Smithfield - RH

'FRENCH COUNTRY' ELEVATION

158 DC - 394 Duncan Creek Rd.,
Lillington, NC 27546

10-24-24 - Redlines - JJ

SLAB FOUNDATION PLAN 'FRENCH COUNTRY'
 SCALE: 1/8"=1'-0" ON 11x17, 1/4"=1'-0" ON 22x34

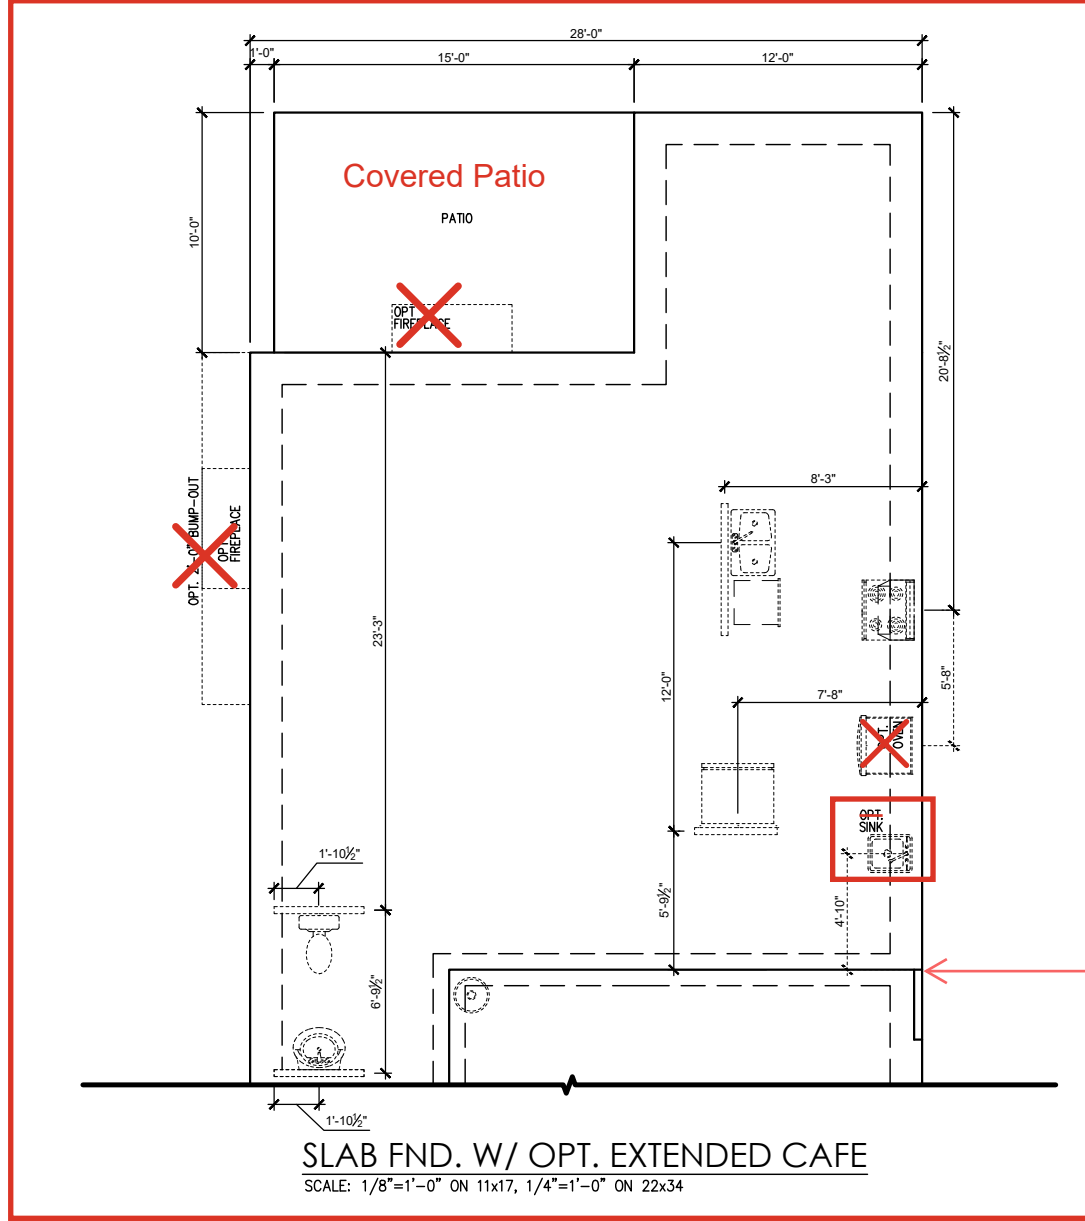
1.1.1b - ext cafe, kitchen and porch

Slab Foundation Options 'French Country'

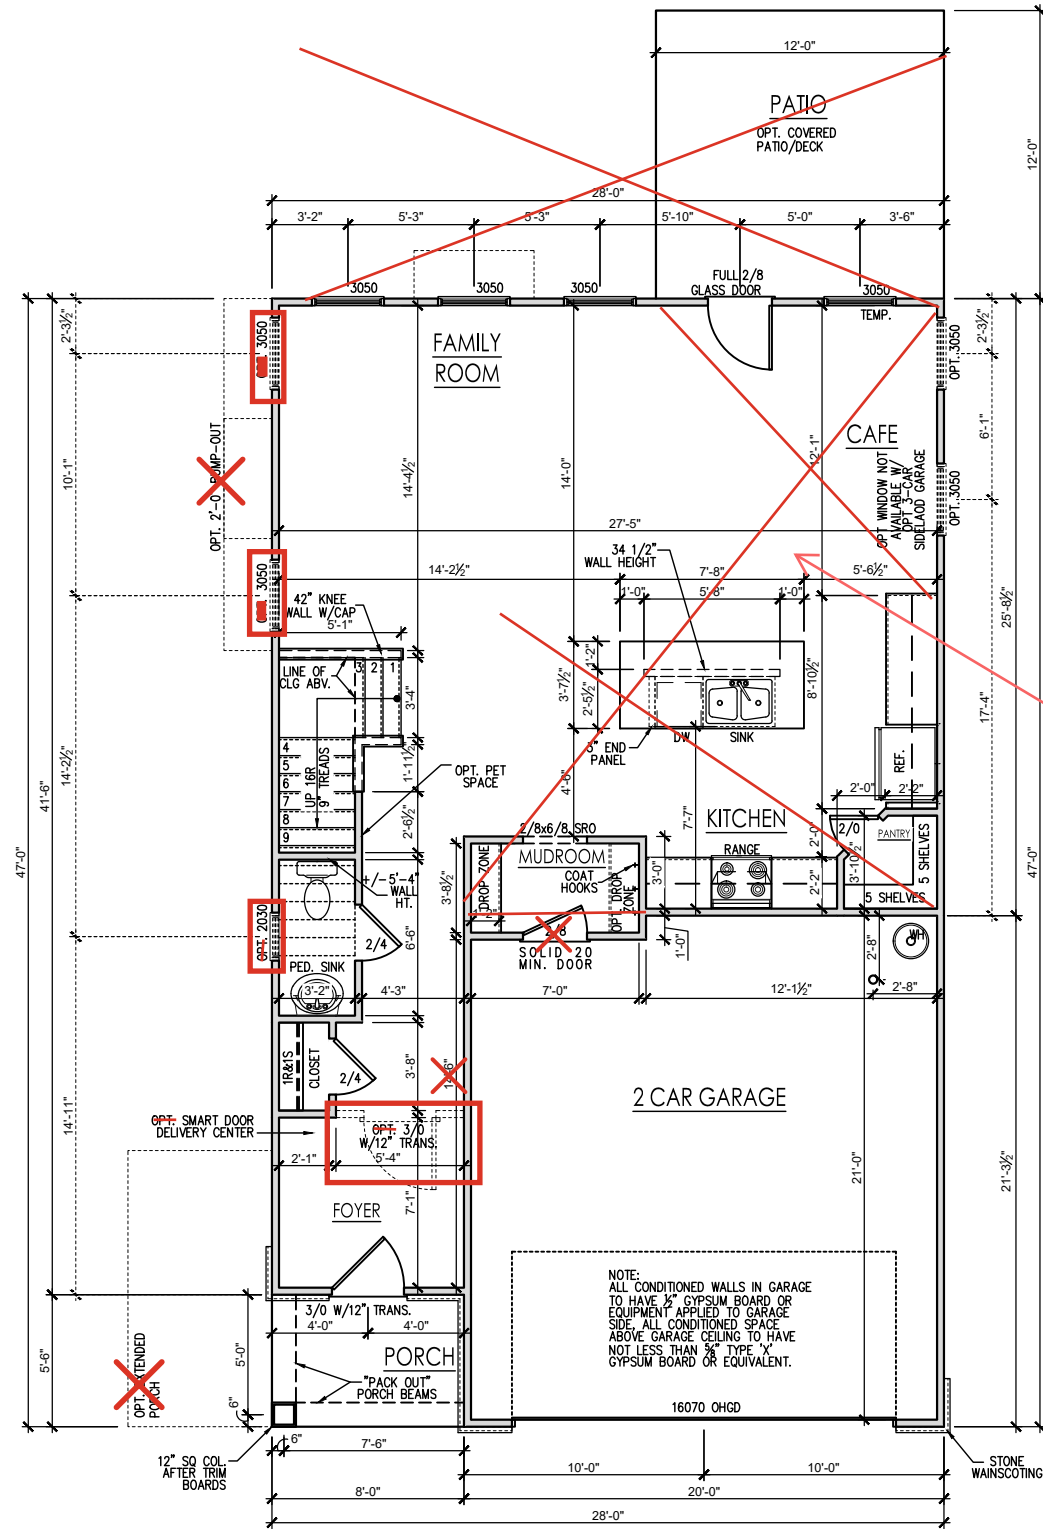
21'-3 1/2" dim to front of garage

FIRST FLOOR PLAN 'FRENCH COUNTRY'
SCALE: 1/8"=1'-0" ON 11x17, 1/4"=1'-0" ON 22x34

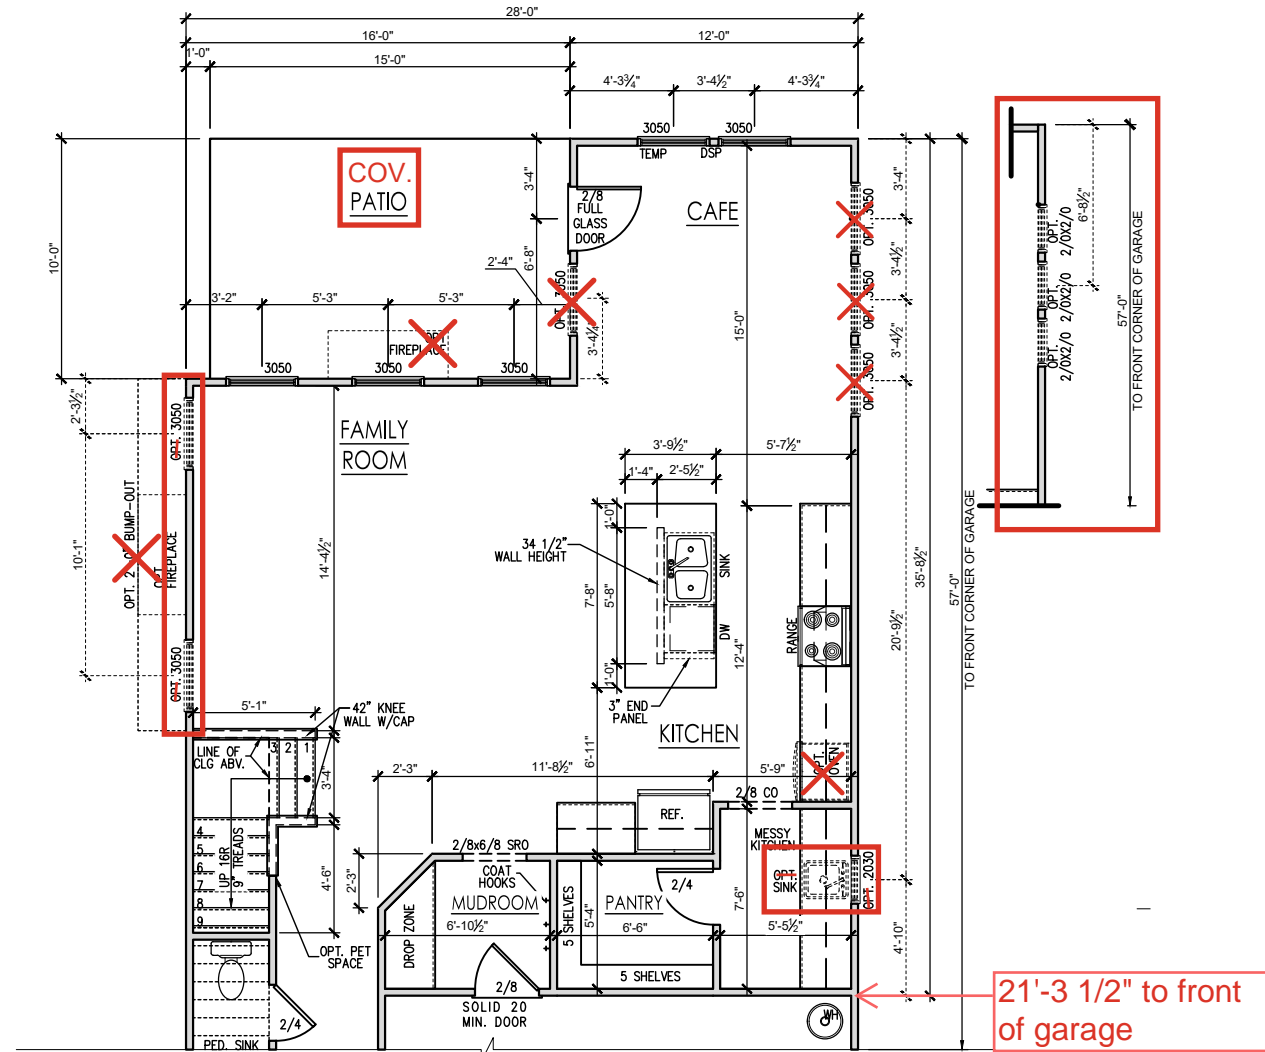
2.1.1b - ext. cafe, kitchen, messy kitchen, pantry

SECOND FLOOR PLAN 'FRENCH COUNTRY'
SCALE: 1/8"=1'-0" ON 11x17, 1/4"=1'-0" ON 22x34

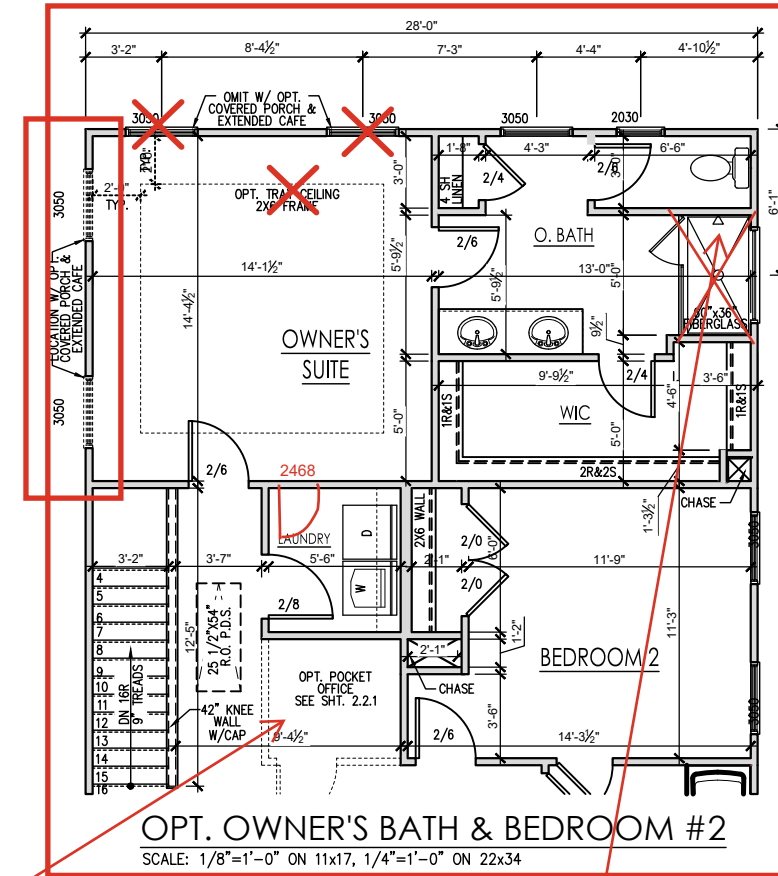
2.2.1 Pocket office

2.2.1 - owner's bath, WIC, Laundry Bed2 & closet

2.2.1 Bed 4

THE SMITHFIELD - RH
Front & Rear Elevations (Slab) French Country

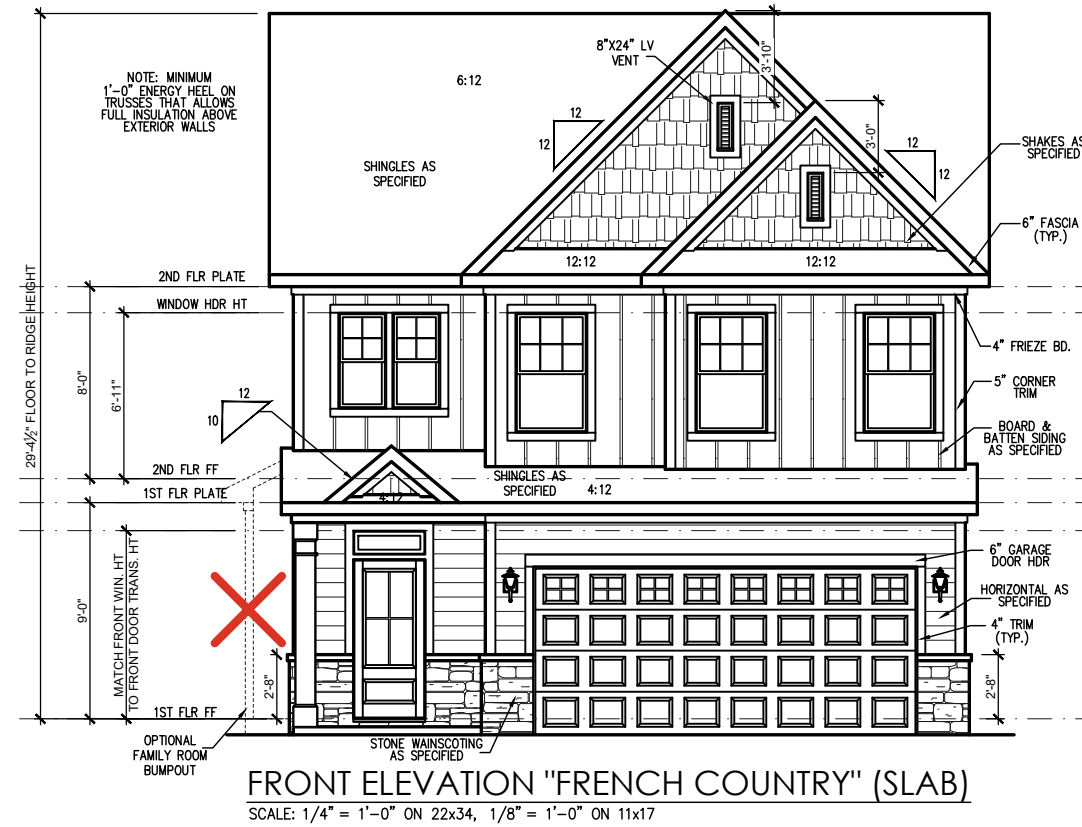
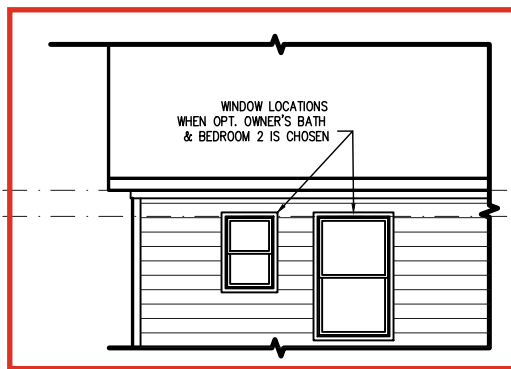
**3.1b - bathroom
windows**

FIRST FLOOR PLAN "FRENCH COUNTRY"

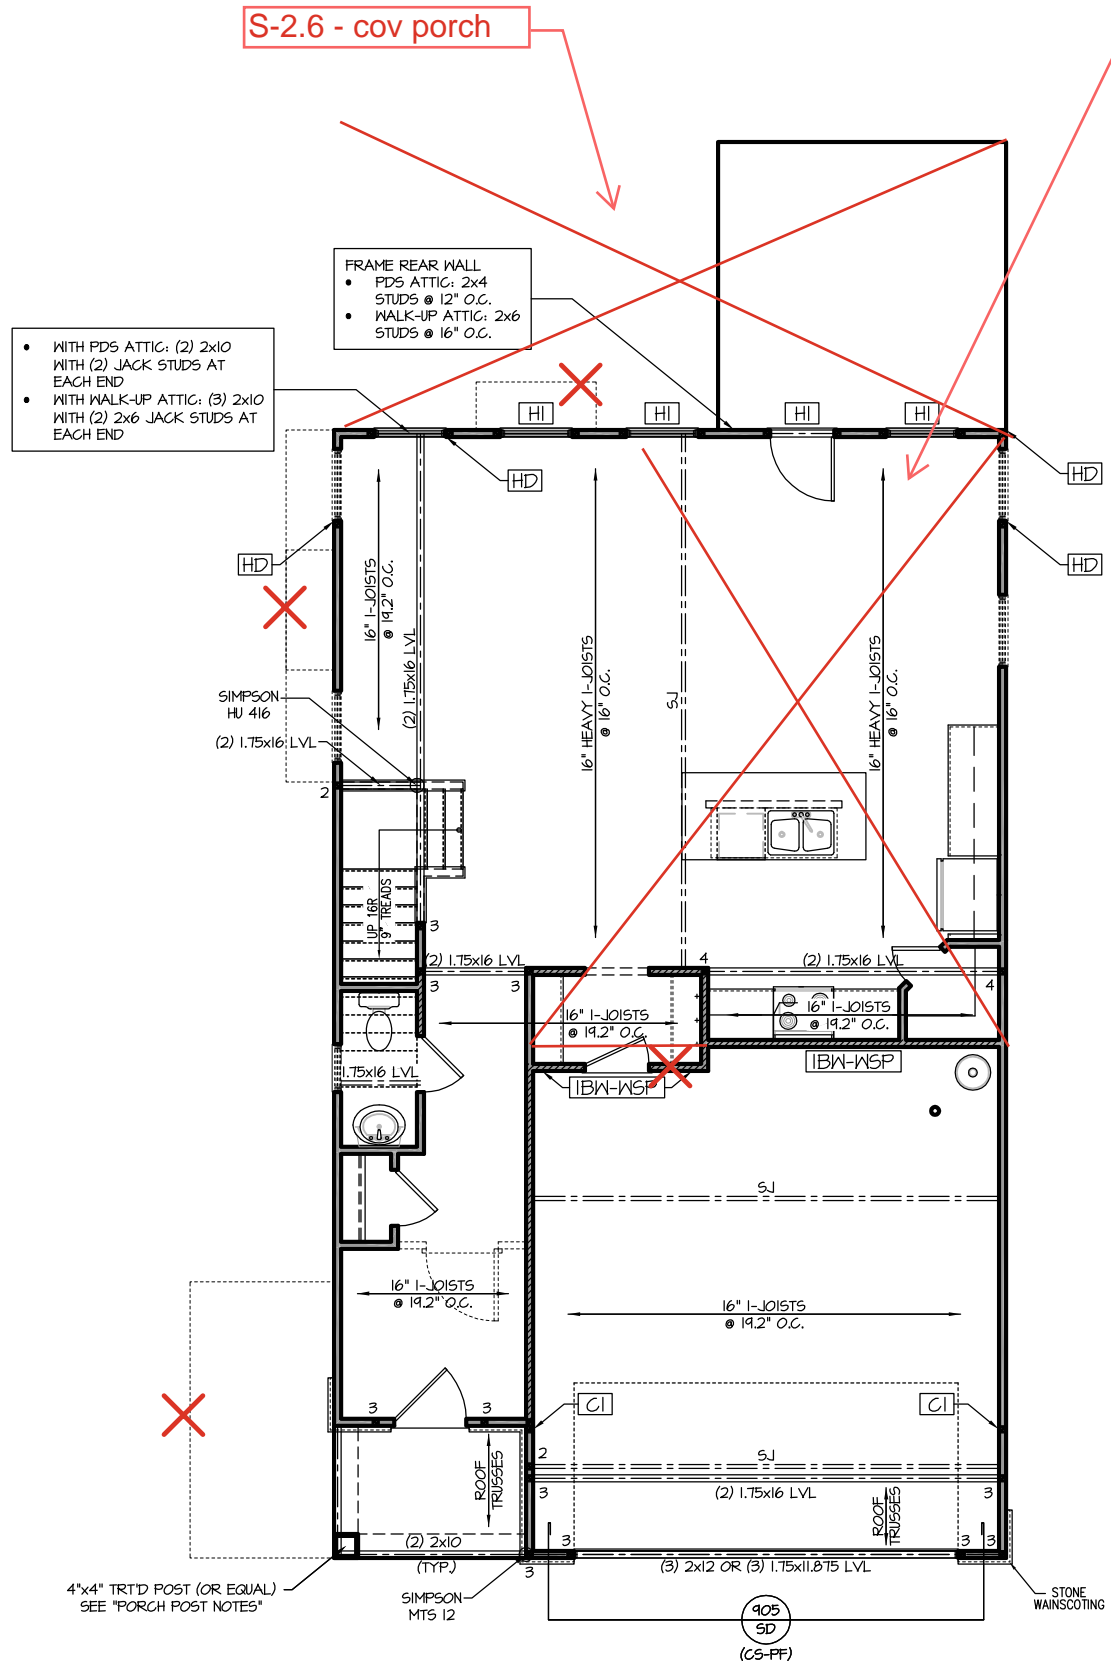
S-2.6 - cov porch

S-2.1.1 - Ext. Cafe,
Kitchen, Messy
Kitchen, Pantry

SECOND FLOOR PLAN "FRENCH COUNTRY"

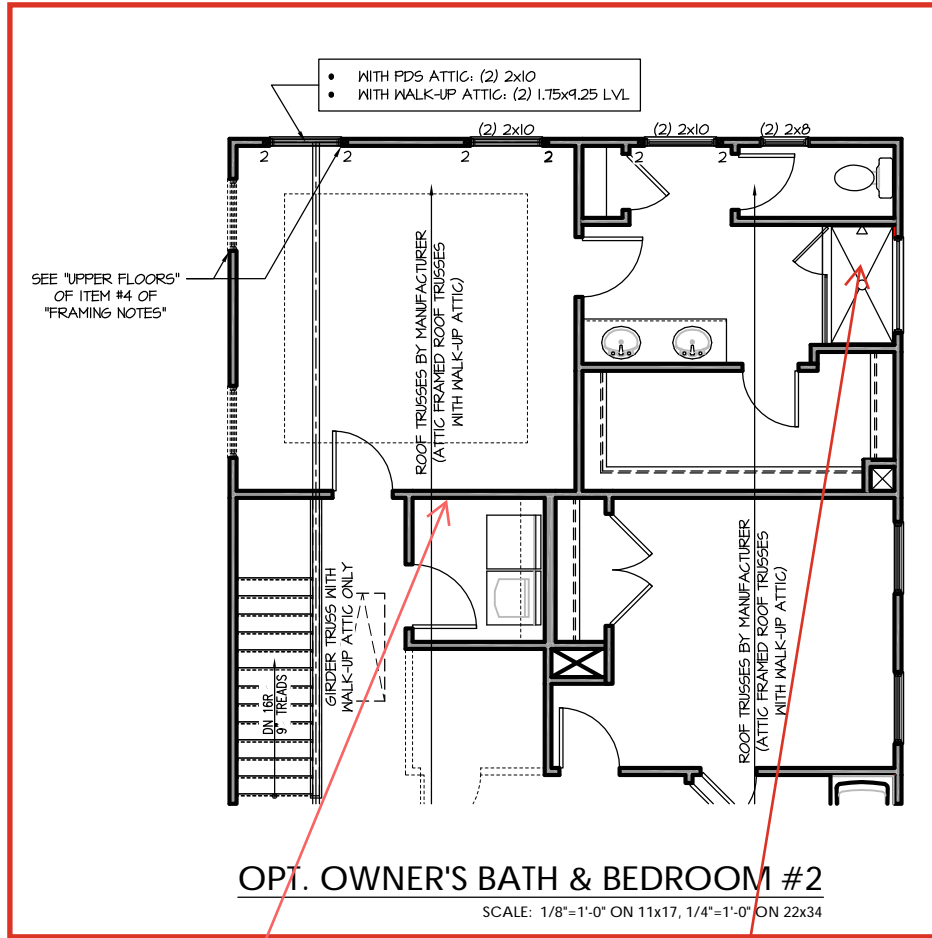
S-2.2.1 - owner's bath, WIC, laundry and bed 2

S-2.2.1 - pocket office

S-2.2.1 - bed 4

2468 door from bedroom to laundry
